Type Coffee Vending Machine	Model KORO PRIME	N° T.I. 11 - 2018
Serial Number 84611149	Subject CHANGE of AIR – BREAK OVERFLOW	ISSUED FOR (X) Action Information X

Detail of hydraulic circuit

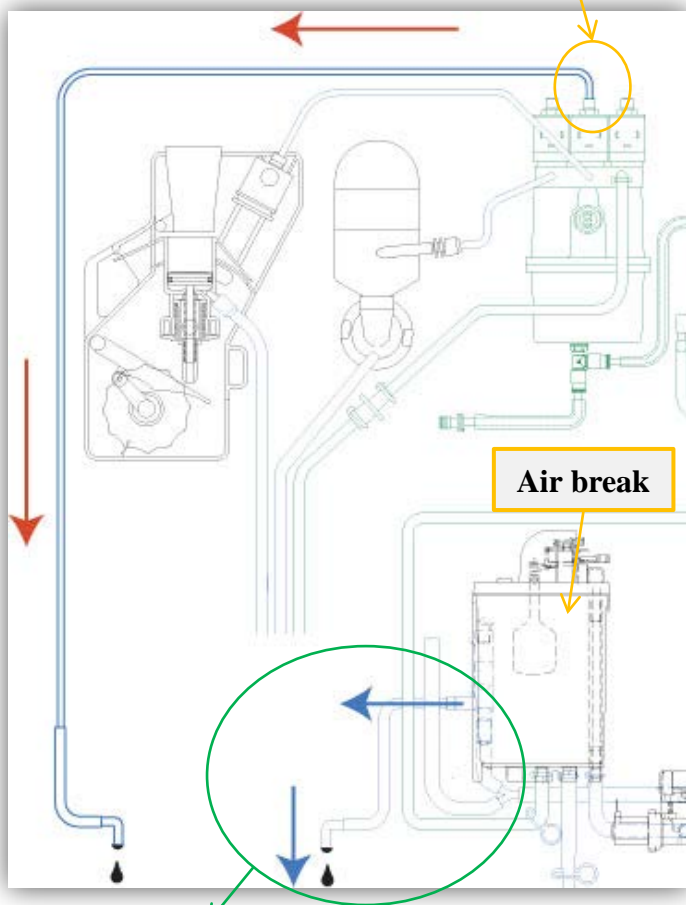
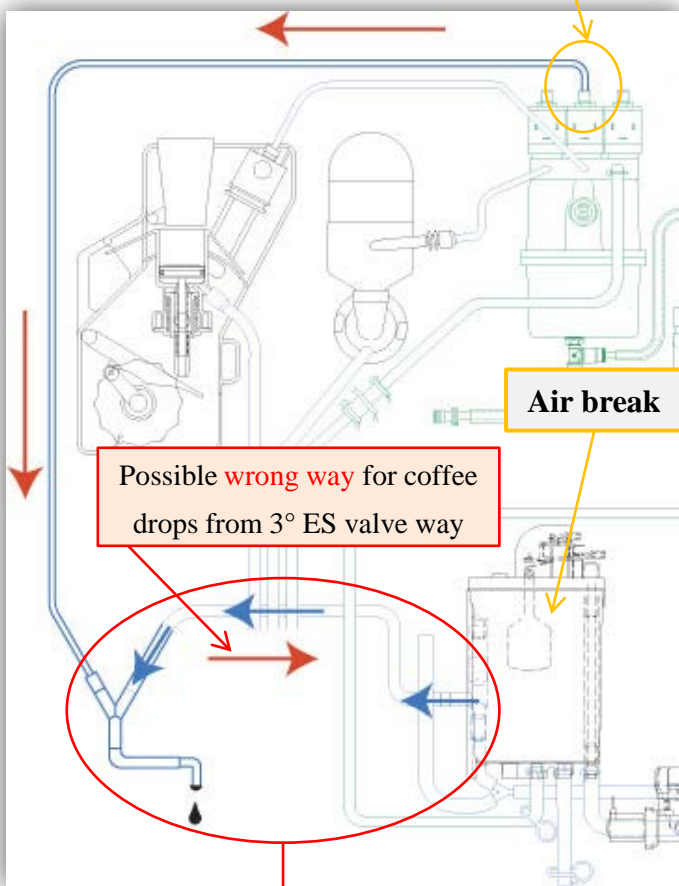
Be informed that with the aim to improve the hydraulic circuit performance.
This to avoid water inlet blocking and in some cases coffee taste on hot water.

the *overflow draining* branch of the *air - break* has been changed as shown below.
The modification will avoid that possible drops of coffee, coming from the discharge branch of the third Espresso solenoid valve way, can be traced back to the air-break

New overflow draining branch is separated from the **output** of the third ES valve

Pre-modification overflow draining branch is connected to the **output** of the third ES valve

New solution

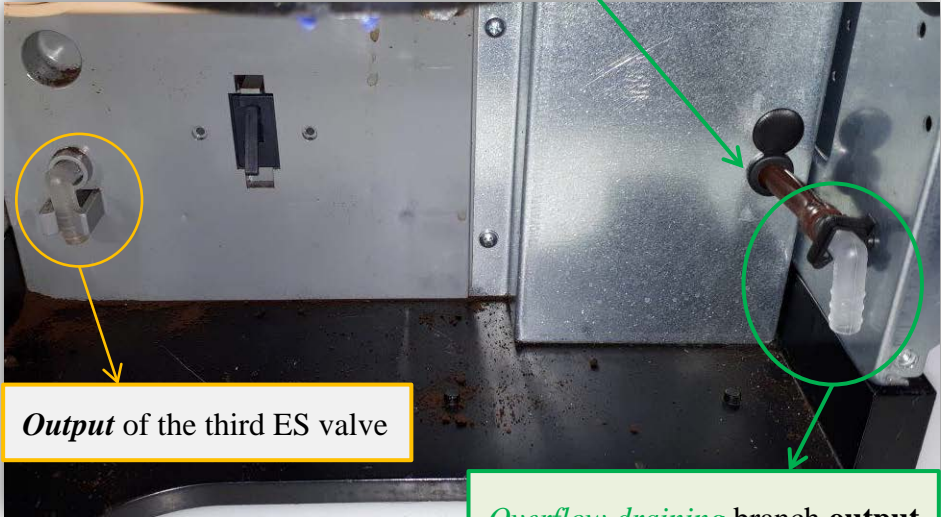
A **hole** has been added on the metal cover to allow the passage of the hose
